**DANE COUNTY DEPT. OF
PUBLIC WORKS, HIGHWAY &
TRANSPORTATION**

ADDENDUM 2

RFB NO. 317023 - ADDENDUM NO. 2

LUSSIER COUNTY PARK BOAT LAUNCH

30-INCH CONCRETE CURB AND GUTTER

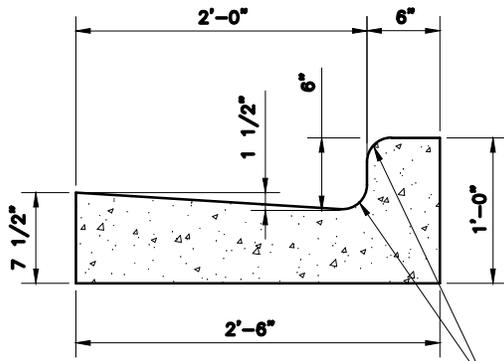
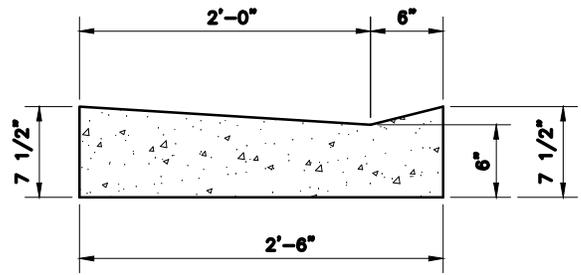
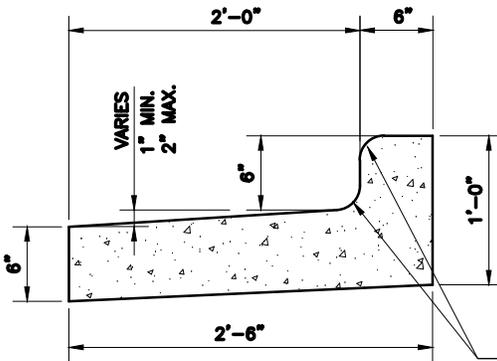
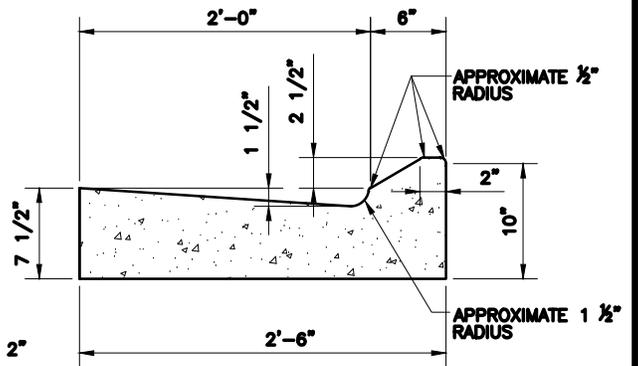
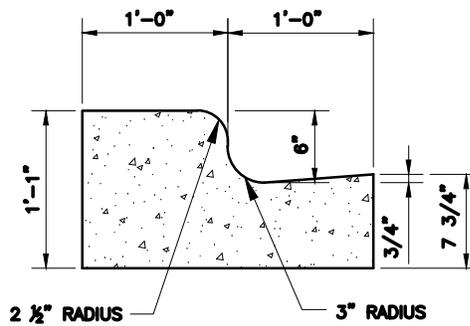
Q: Can you provide a detail of the curb and gutter listed for the project?

A: Standard 30-in per attached detail.
